QUESTION Reinforcing Steel
5J.1

QUESTION 5J.2 Describe the pressure/thermal load in the liner.

~~00210~~

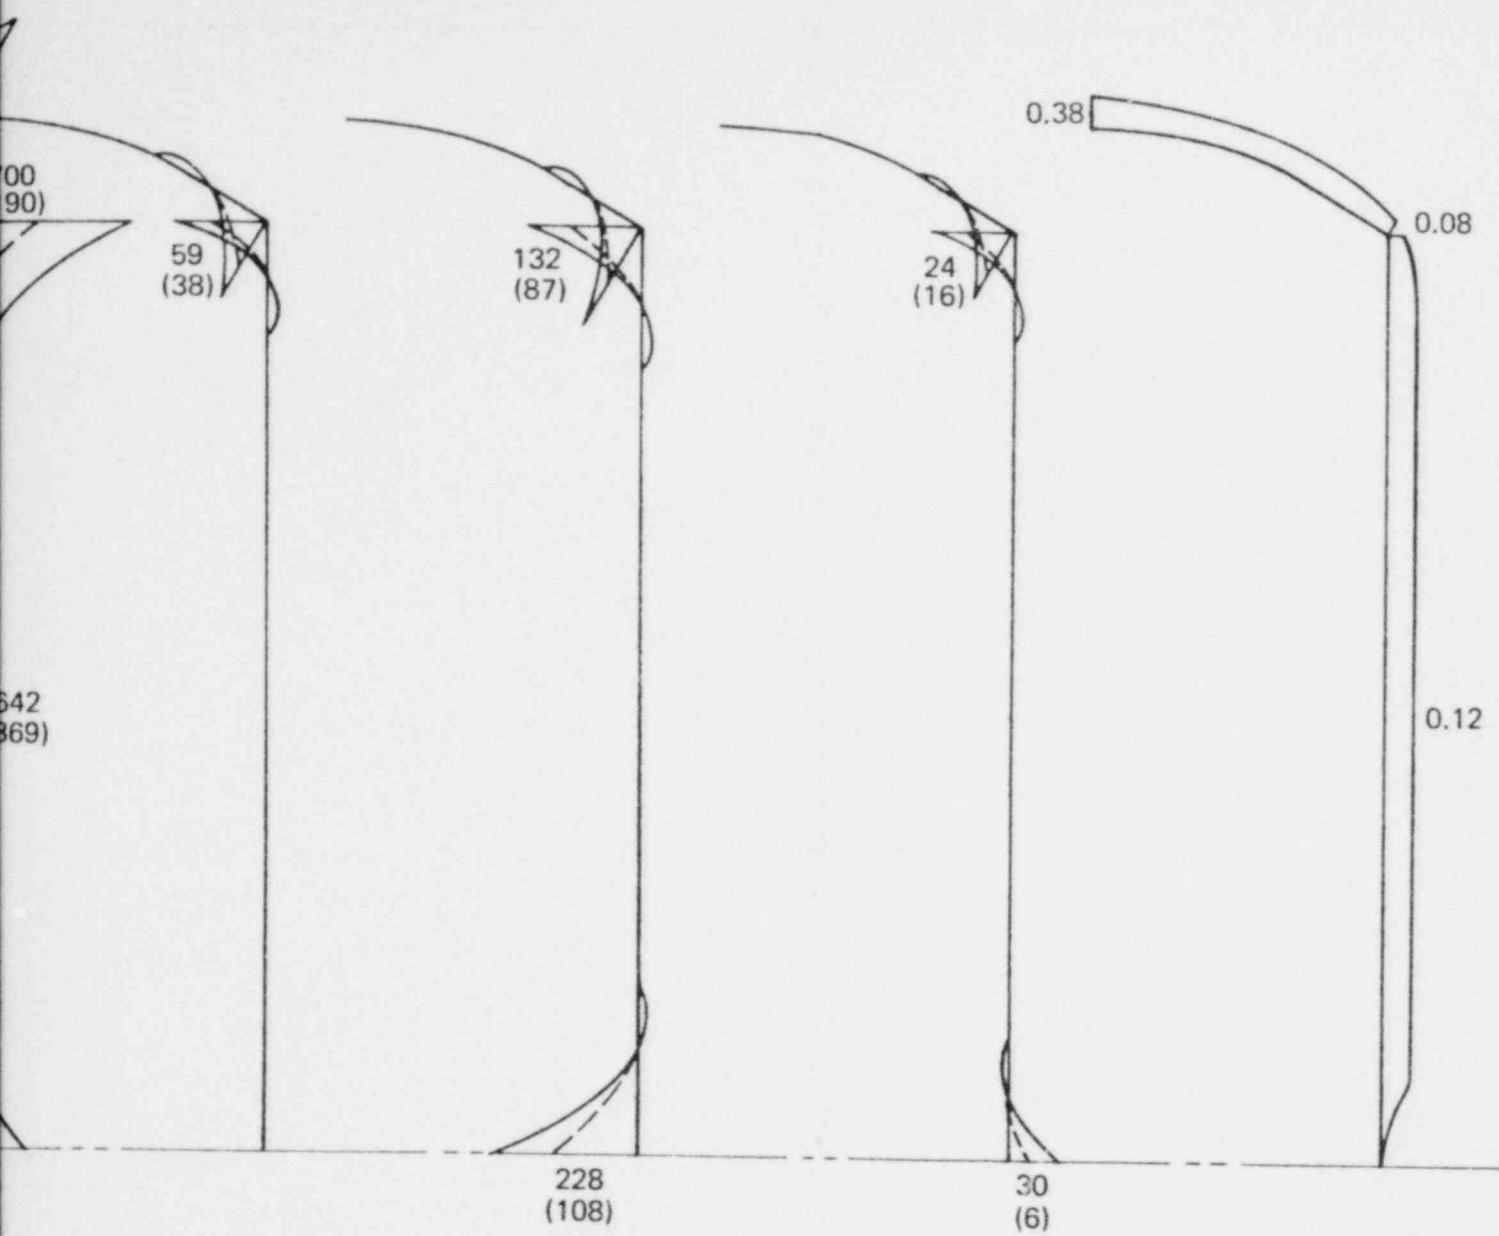
Provide the following:

- (a) A preliminary design drawing of the containment, presenting details of the base slab, dome ring beam, cylinder-slab juncture, vertical buttresses and inspection gallery; showing reinforcing, prestressing, and liner features, including liner anchors;
- (b) Scaled load plots for moment, shear, deflection, longitudinal force, and hoop tension, in order that an appraisal can be made of the significance of the various loadings which influence the containment design; Provide these plots as a function of containment height for prestress, dead, pressure, design earthquake, wind, liner thermal (normal and accident) and concrete thermal (normal and accident) loading;
- (c) The normal operating transient and steady state thermal gradients to be used in the design of the containment for typical winter and typical summer day;

- (b) Preliminary scaled load plots for moment, shears, forces, and deflections are included in Figures 5J.7.2-1 through 5J.7.2-6 for all loading conditions. A plot of the thermal loading of the liner plate has been excluded due to the nature of its membrane action under prestress and thermal conditions. However, a description of this action is discussed in Questions 5J.7.4, 5J.7.18, 5J.7.19 and 5J.7.20 as well as Sections 5.1.3.4, 5.1.4.6 and 5.1.4.9 of the PSAR.

FIGURE 5J.7.25-1
PENETRATION LOADS

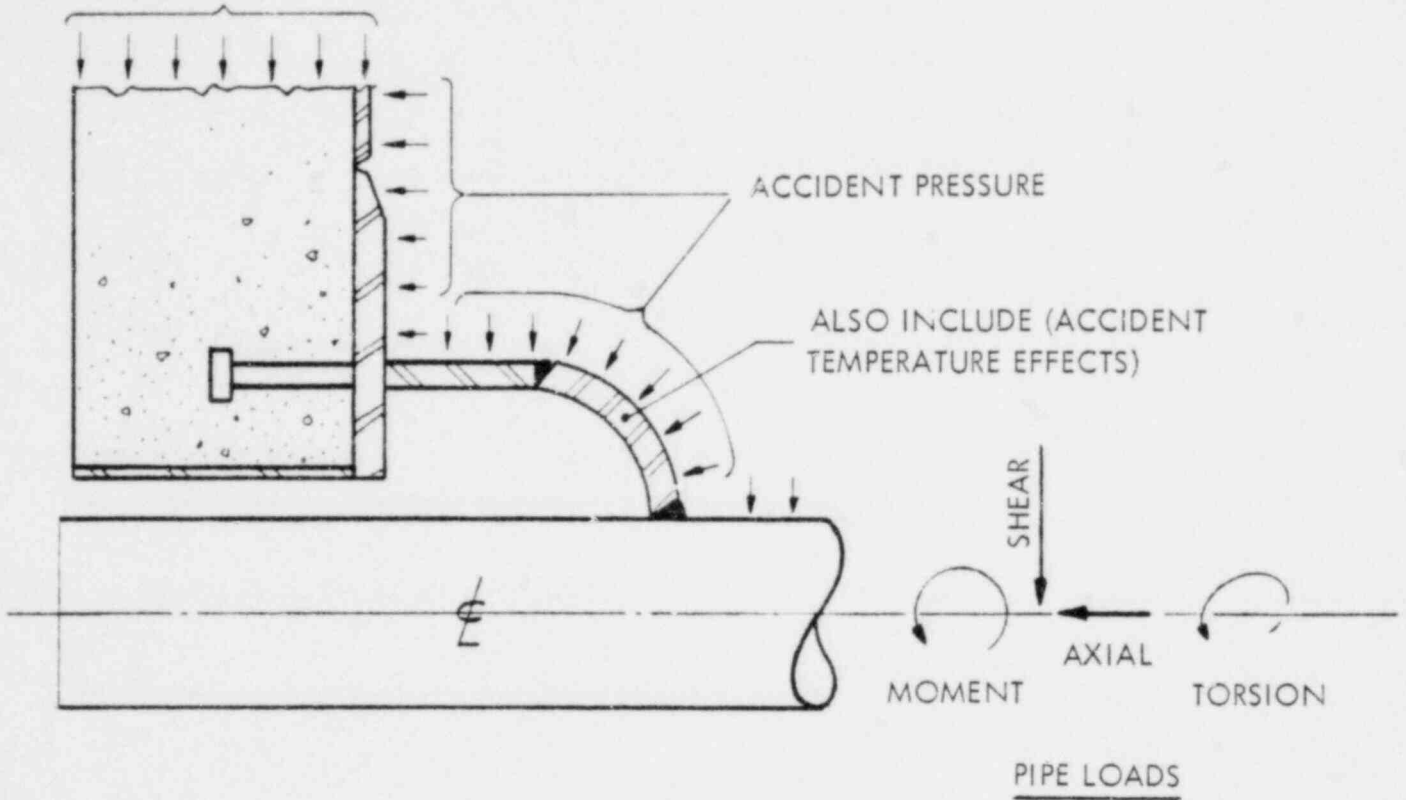
Describe the analytical procedures for analysis of liner stresses around openings. Also, provide the method of liner design to accommodate these stresses and the related stress limits. Justify the proposed thickening of the liner at penetrations. Discuss the liner anchors at this location.

The combining of stresses from all effects will be done by the methods outlined in the ASME Boiler and Pressure Vessel Code, Section III, Article 4, Figure 414. The maximum stress intensity will be the value from Figure N-415 (A) of the previously referenced code. Shown in Figure 5J.7.25-1 is a typical penetration and the applied loads.
